RC245088

s92 - Request for Further Information and Affected Party Approval

I have reviewed the resource consent application **RC245088** by Woolworths New Zealand Limited to establish and operate a supermarket and small-scale ancillary retail tenancies, including associated earthworks, access, carparking, signage and landscaping at 597 East Maddisons Road, Rolleston. More information is needed so that I can better understand your proposal and its potential effects.

**RE: Woolworths Rolleston
Selwyn District Council RFI Transport Responses**

LANDSCAPE MASTERPLAN
SITE WIDE
RESOURCE CONSENT

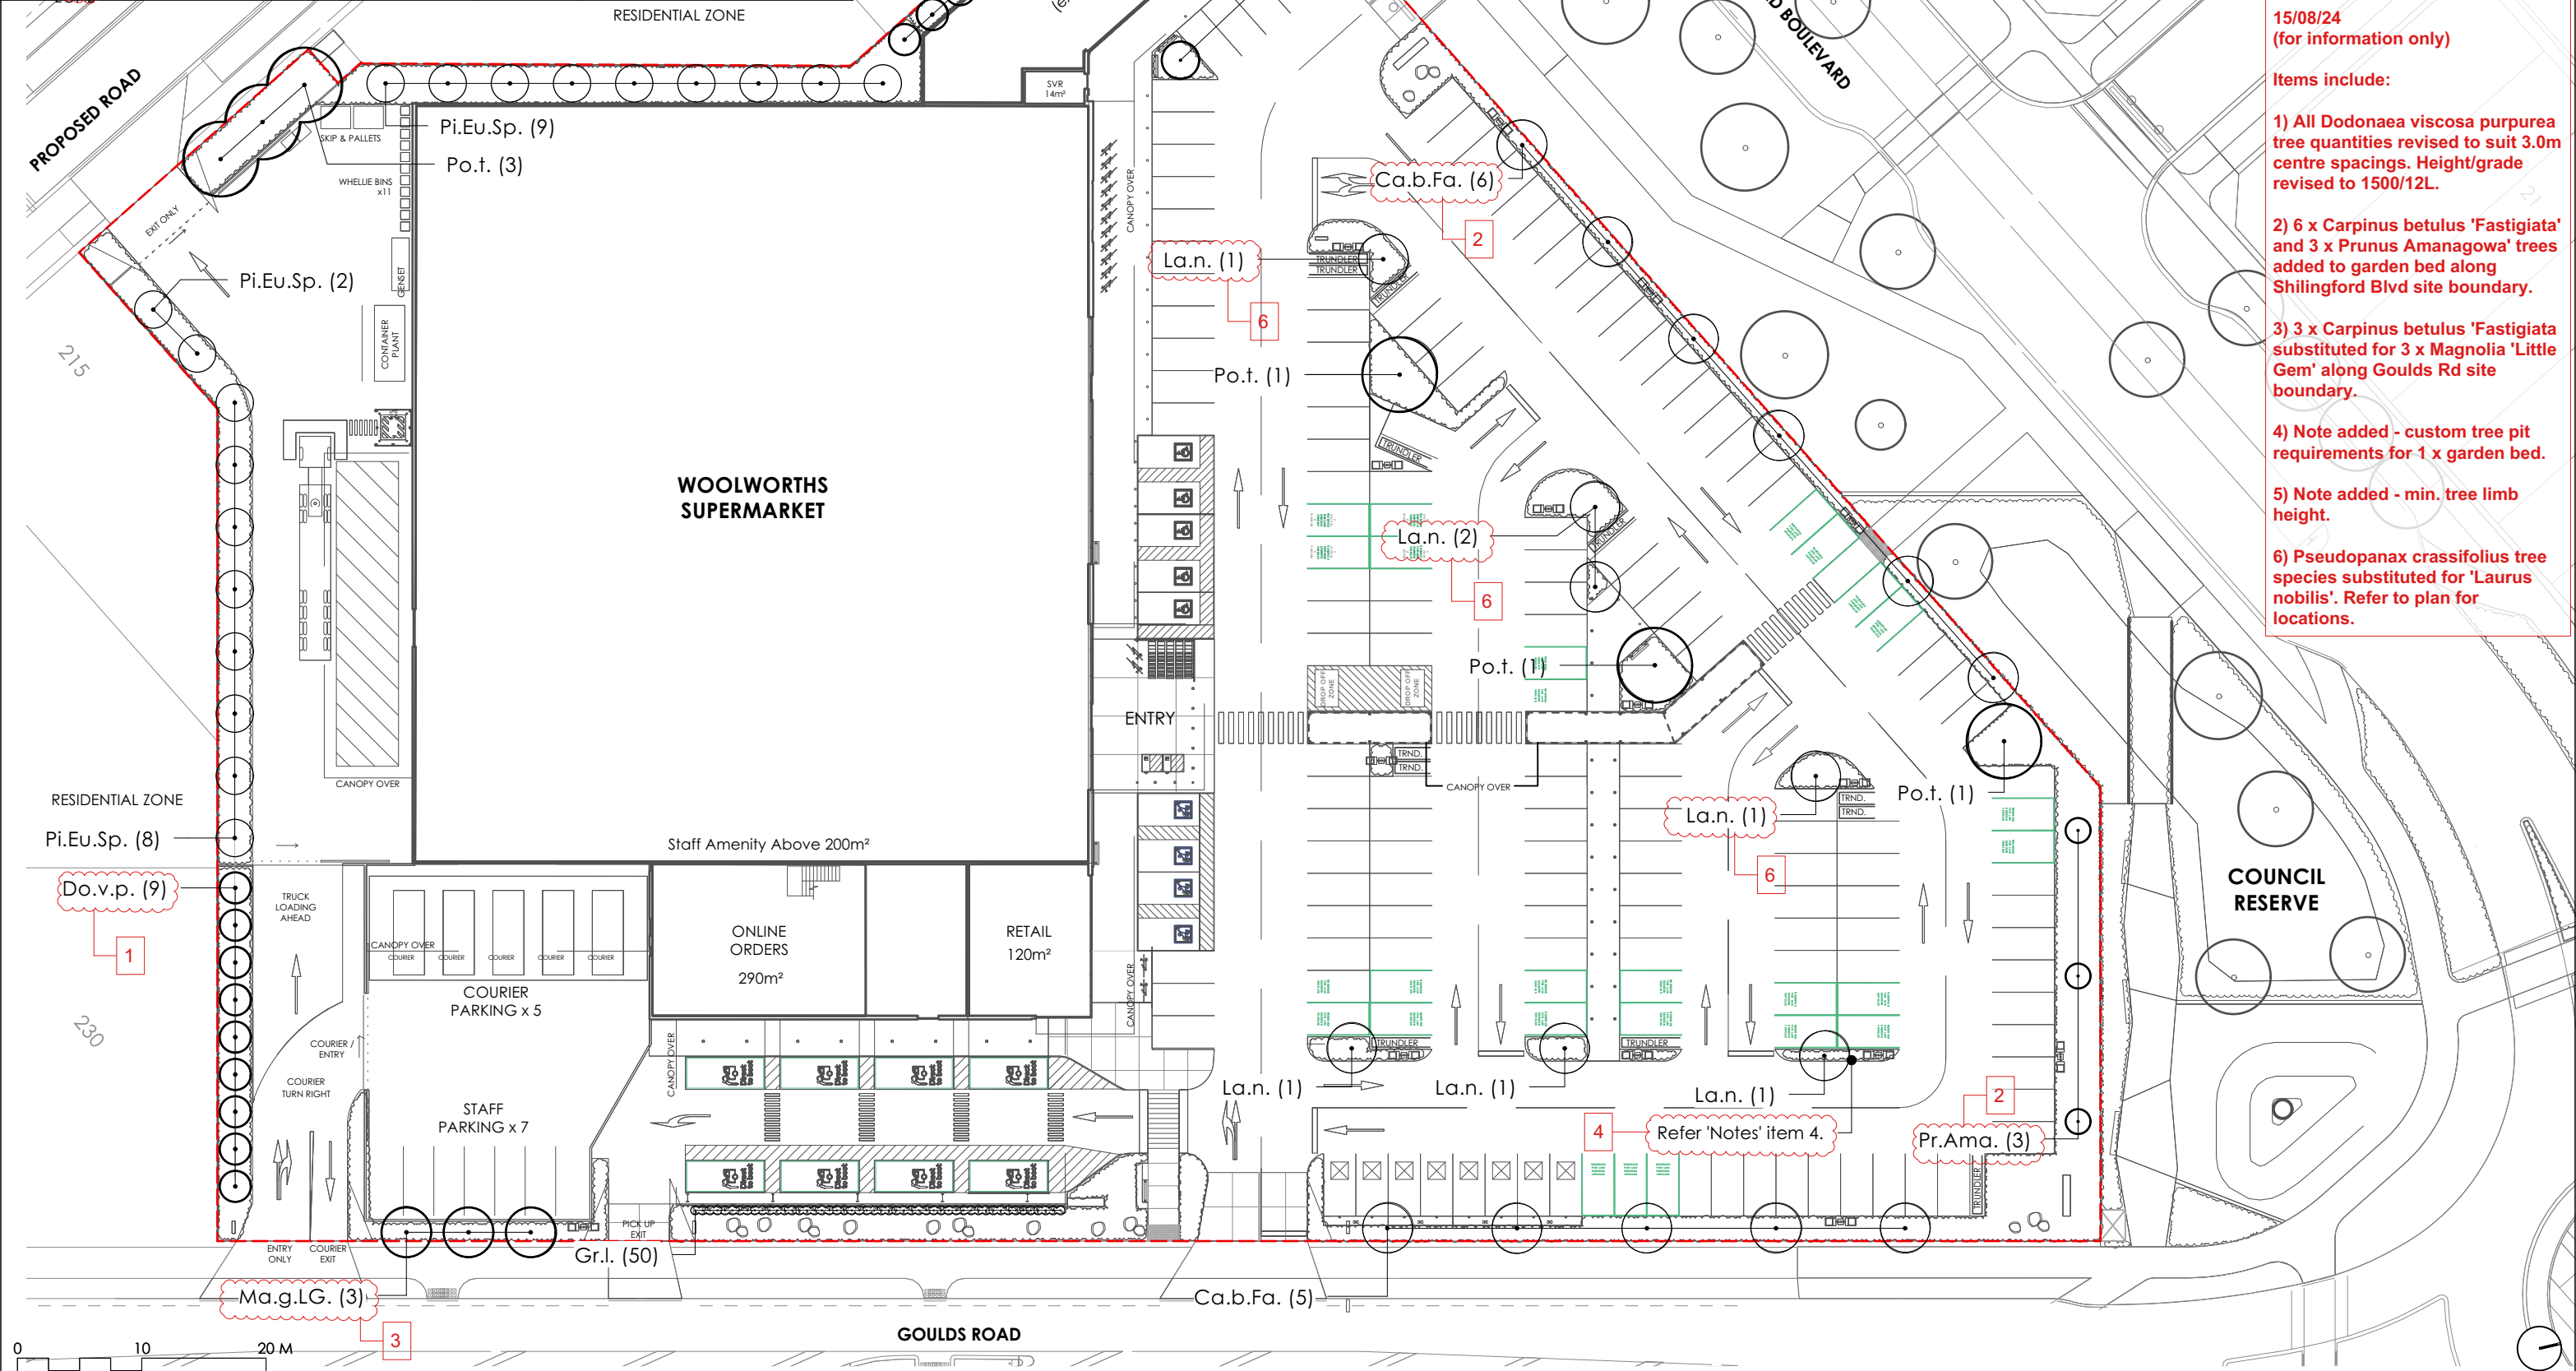
Orphan Bicycle stands	Conflict with location. Can WWNZ relocate – not concerned as to whether covered.	Need to be located proximate to eastern Retail Tenancy. Limited options on pavement so as not to conflict with ped movements.	Relocate to northern façade of retail tenancy. One side only. Additional cycle space added to cluster at the West.	Would like to see further detail on bike stand location vs bollards/wheelstops. In general support new location of bike stands.	
Accessible Parking Space	Doesn't comply with requirements.	Stantec – width next to Trundle Bay is sufficient and flat.	Extend line marking	Support the linemarking.	✓ Refer Amended Plans
Interface North and North East / Tree planting in Carpark.	Absence of sufficient trees within carpark, and reliance on planting in the vested road reserve (3rd party mitigation) to provide mitigation to the north along Shillingford Boulevard (and Goulds Road).	Agreed- custom test pit for NE internal carpark tree pit would be sufficient. Given width of grass strip add additional 'fastiglato' trees at spacing of 10.4m to 15.6m to fit within planting for vested road reserve. Three 'Amanogawa' cherry to be		Support the additional trees on boundary.	✓ Refer Amended Plans

retained adjoining roundabout and providing views through to site.			
Lancewoods Additional comments SDC				Forgot to mention in the meeting that I had asked for a species change for the Lancewoods in the carpark as these are not big enough. If a new species can be suggested.	4x lancewoods substituted to Bay Laurel Refer Amended Plans.
Landscape Amendments WWNZ					Replacement of Japanese cherry blossoms in front of Courier area to Magnolia grandiflora 'Little Gem'.

- KAMO MARSH**
REV G / RFI CHANGE REGISTER
- 15/08/24**
(for information only)
- Items include:**
- 1) All *Dodonaea viscosa purpurea* tree quantities revised to suit 3.0m centre spacings. Height/grade revised to 1500/12L.

- 2) 6 x *Carpinus betulus* 'Fastigiata' and 3 x *Prunus Amanogawa* trees added to garden bed along Shillingford Blvd site boundary.
 - 3) 3 x *Carpinus betulus* 'Fastigiata' substituted for 3 x *Magnolia* 'Little Gem' along Goulds Rd site boundary.

- 4) Note added - custom tree pit requirements for 1 x garden bed.
 - 5) Note added - min. tree limb height.
 - 6) *Pseudopanax crassifolius* tree species substituted for '*Laurus nobilis*'. Refer to plan for locations.
